FILVIA Report

Lyrenacarriga WF

Document Title: **FI LVIA Report**

1. RFI – LYRENACARRIGA LVIA INPUT

Figure 1-1 Extract from the 3rd Party Photomontage Booklet showing the location of Viewpoint 6 in relation to the proposed turbines

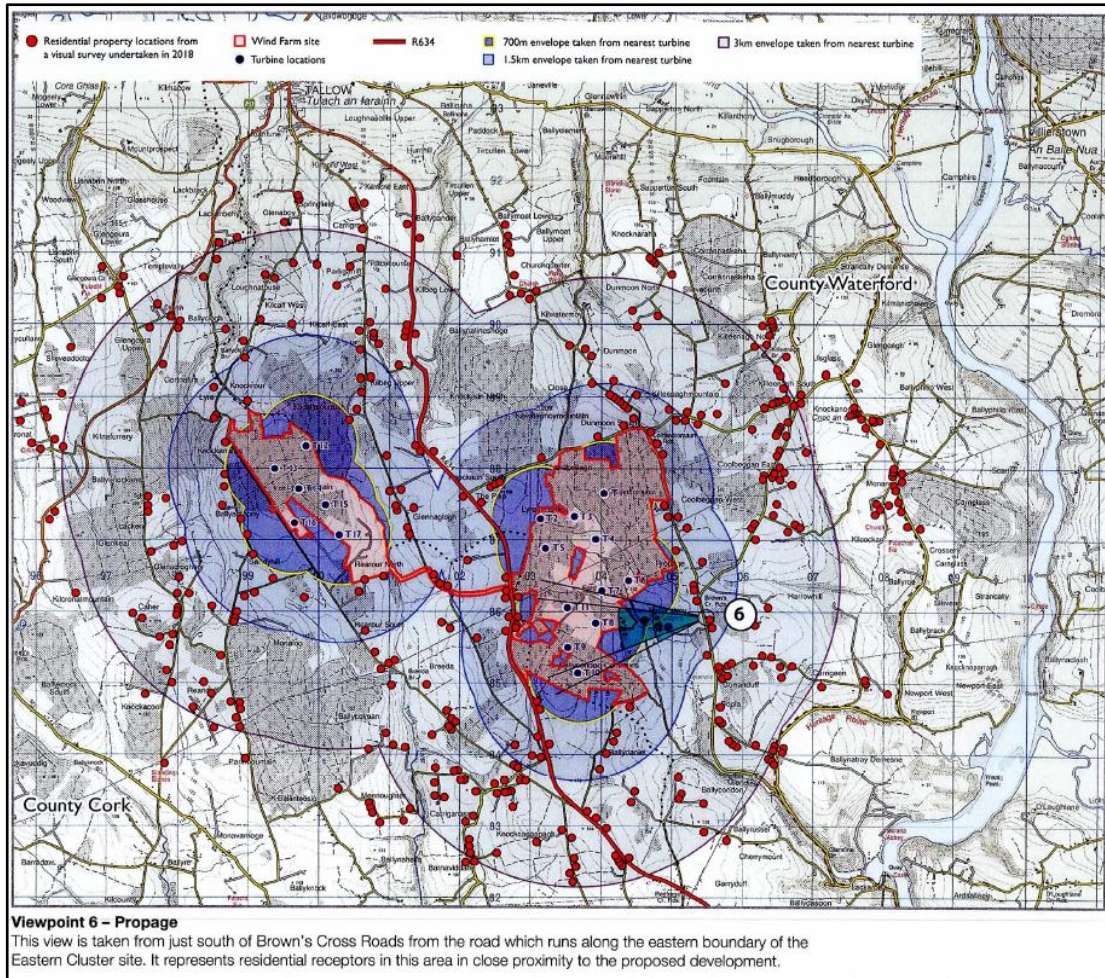
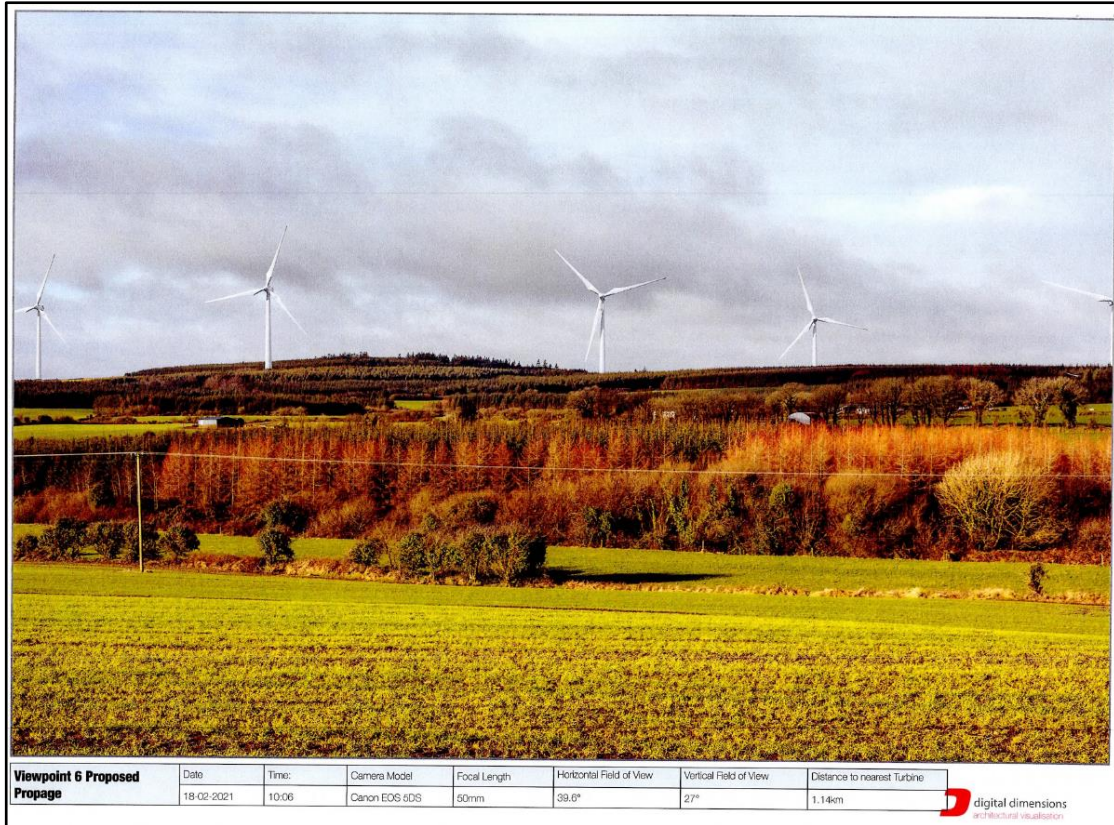
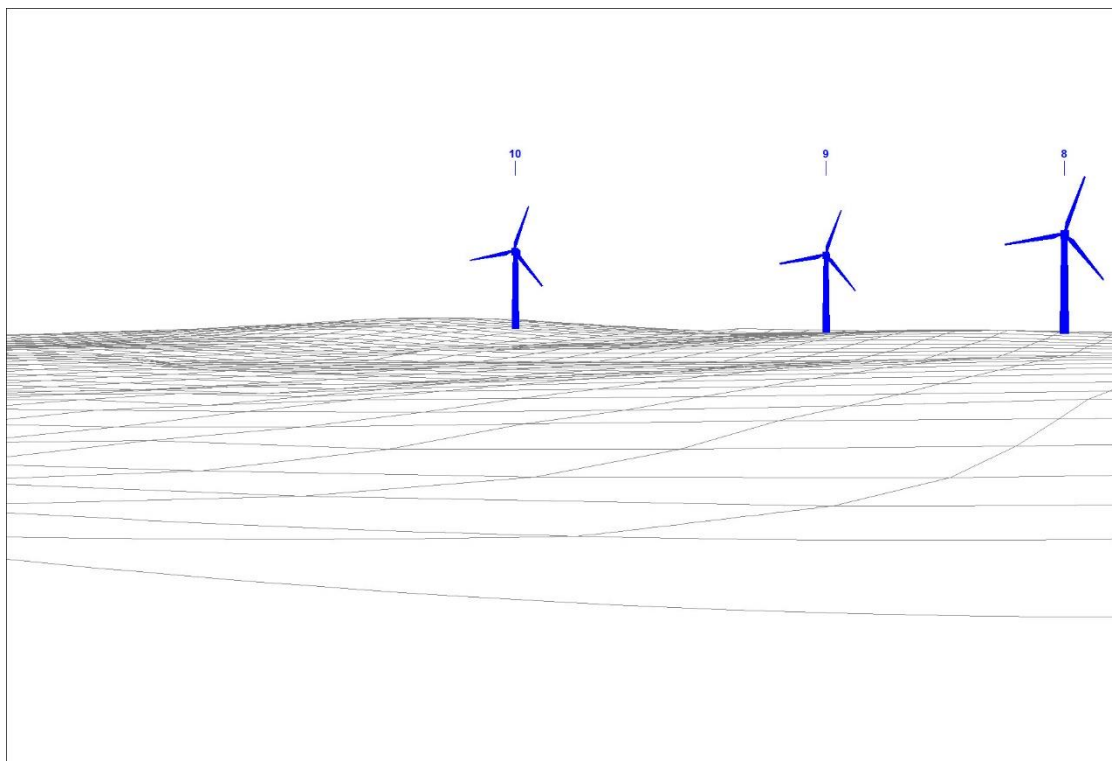
Contained within this section are number of images which demonstrate the inaccuracy of turbine locations within the 'Proposed' View from Viewpoint 6. Viewpoint 6 is located to the east of the eastern cluster, along a small local road and represents the view from a number of residential receptors located along the adjacent stretch of road. The approximate location of the Viewpoint is shown below in an extract from the 3rd party Photomontages Booklet. As can be seen from the map below in Figure 1-1, there are supposed to be five turbines visible within the horizontal extent of the 39.6-degree view shown, with turbine T08 (the central turbine of the five turbines in the view) located noticeably closer to the Viewpoint location than turbines T9 and T10. It is notable therefore, that in Figure 1-2 below, which shows an extract from the 3rd Part Photomontages Booklet that turbine T8 (the central turbine within that view) appears to be located behind the ridgeline in the image, whereas T9 and T10 (to the left-hand side of the image) appear closer than T8, contrary to what is displayed on the Map shown in Figure 1-1.

However, this incorrect rendering of turbines within the view is only a minor mistake in relation to the mistaken placement of turbines within the same view illustrated below. Figure 1-2 below is an image extract from the 3rd Party Photomontage booklet showing a 39.6-degree horizontal field of view of the Proposed Development from Viewpoint 6. It can be seen that the left-hand extent of the turbines within this view extends all the way onto the far side of the rise in elevation seen in the left background. Figure 1-3 below is a wireframe image prepared by MKO which shows the locations of the turbines in relation to the topography from Viewpoint 6. It is noted that the model prepared by MKO for this wireframe image uses the turbine locations indicated on the extracted map from the 3rd Party Photomontage booklet, Figure 1-1 below (which do align with the actual turbine locations for the Proposed Development). However, it can be clearly seen from this wireframe image that the turbines are incorrectly positioned within the 'Proposed' View contained in the 3rd Party Photomontage. As seen in the wireframe image, the left-hand extent of the turbines should begin on the right-hand side of the hill seen in the extract of the Proposed View and that is clearly not the case. A simple comparison between the wireframe image prepared MKO (it is also notable that no wireframe images accompanied the 3rd Party Photomontages) and the Proposed View shows that the turbines are incorrectly positioned and rendered within the view.

Figure 1-6 Wireframe Image Prepared by MKO showing the actual locations of the turbines in relation to the topography from this viewpoint location (Viewpoint 7)

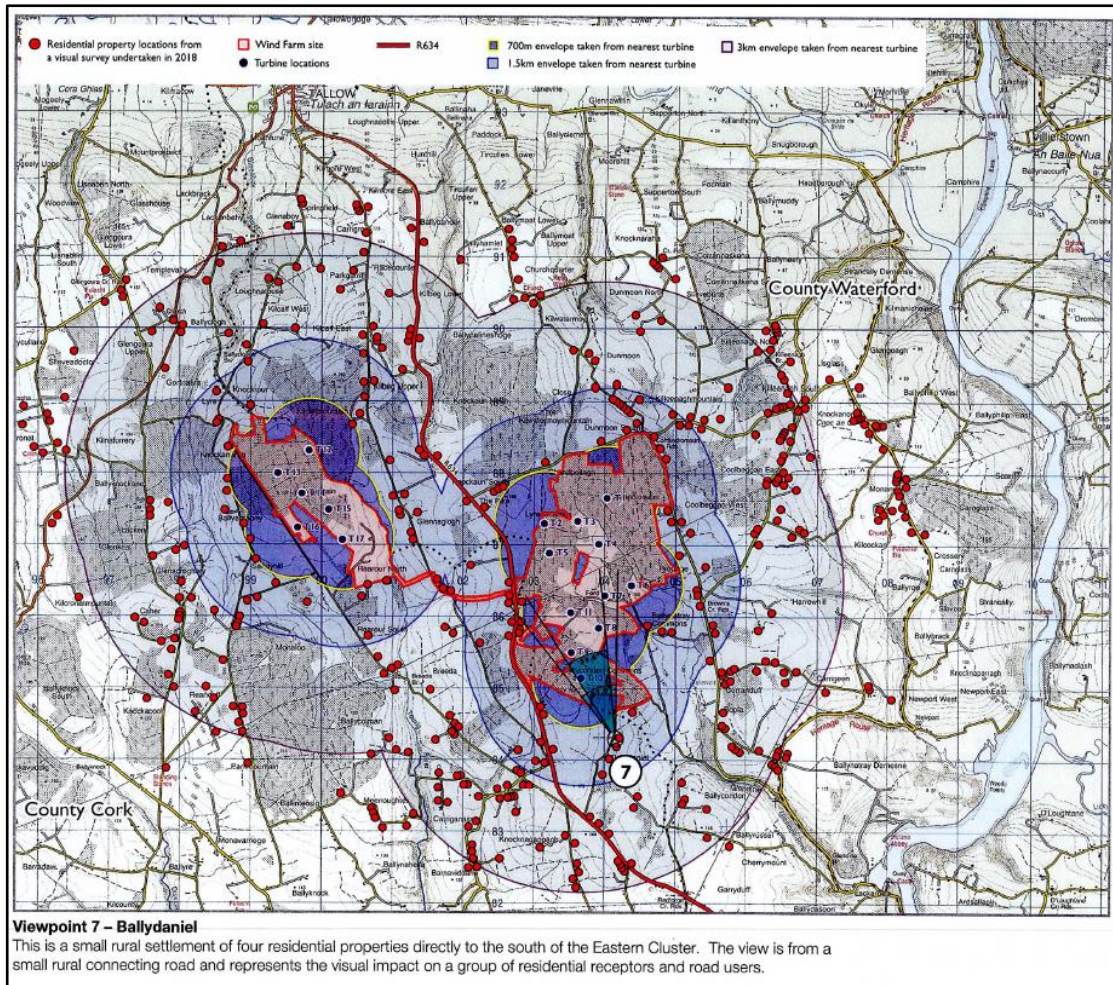
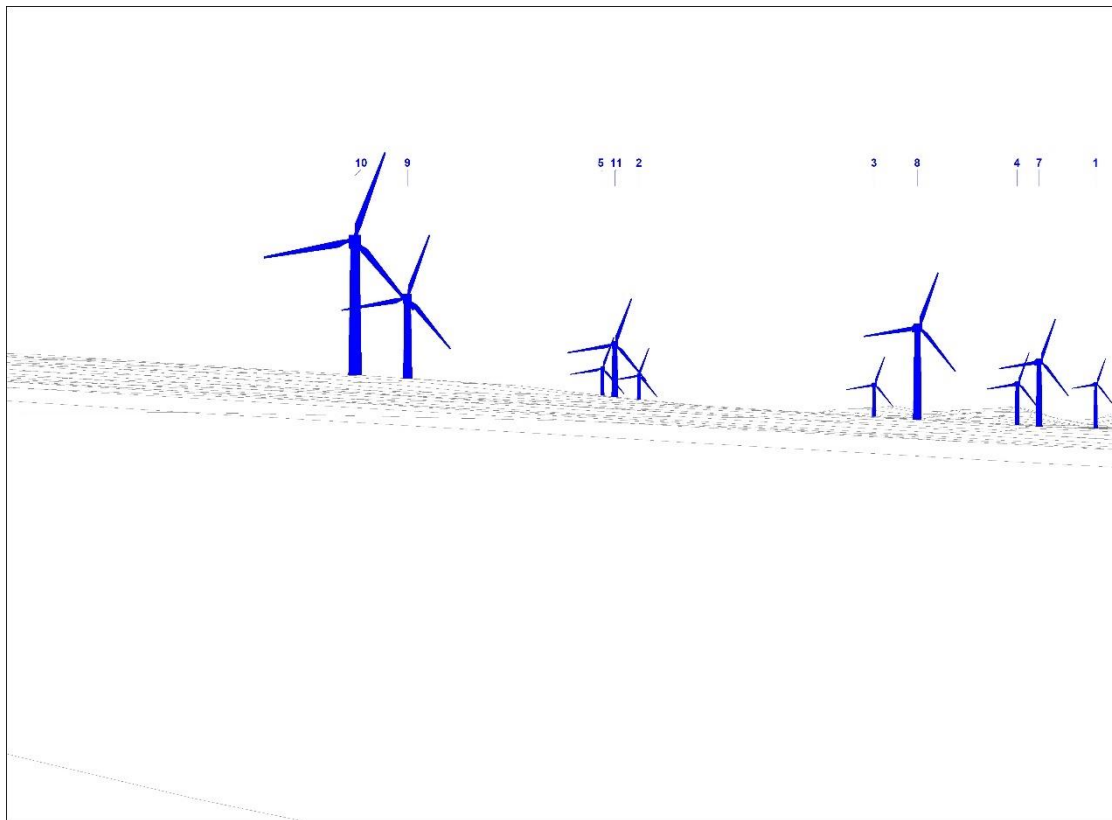
Contained within this section are number of images which demonstrate the inaccuracy of turbine locations within the 'Proposed' View from Viewpoint 7. Viewpoint 7 is located to the south of the eastern cluster of the turbines, along a small local road and represents the view from a number of residential receptors located along the adjacent stretch of road. The approximate location of the Viewpoint is shown below in an extract from the 3rd party Photomontages Booklet. As can be seen from the map below in Figure 1-4 there are potentially 9 turbines visible within the 39.6-degree horizontal extent of the Proposed view, with T10 and T9 almost perfectly aligned within the left-hand side of the view and turbine T8 located in the right-hand side of the view. These three turbines are located closest to the viewpoint and should therefore appear largest within the view. To reiterate, there should be two large turbines closely aligned in the left-hand side of the view, with one large turbine in the right-hand side of the view, at the least. This is demonstrated in the wireframe image prepared by MKO from this viewpoint location (Viewpoint 7).

It can be seen from Figure 1-6 above that from Viewpoint 7 turbines T10 and T9 (the two closest and thus largest) should be positioned close together within such a view, with the third closest turbine (T8)

positioned to the right of these within that same view. It can be seen clearly above in the extract of the Proposed Photomontage of Viewpoint 7 from the 3rd Party Photomontage Booklet (Figure 1-5) that turbines T10 and T9, which should be the largest turbines in such a view, are not located close to each other. Turbine T9, which is the second largest turbine, presumably the turbine seen to the right of the image below, is located much closer to T8, which does not match what the map above showing the turbine locations would suggest. There has clearly been an error with the placement of turbines the preparation of this Photomontage. A simple comparison between the wireframe image prepared MKO (it is also notable that no wireframe images accompanied the 3rd Party Photomontages) and the Proposed View shows that the turbines are incorrectly positioned and rendered within the view.
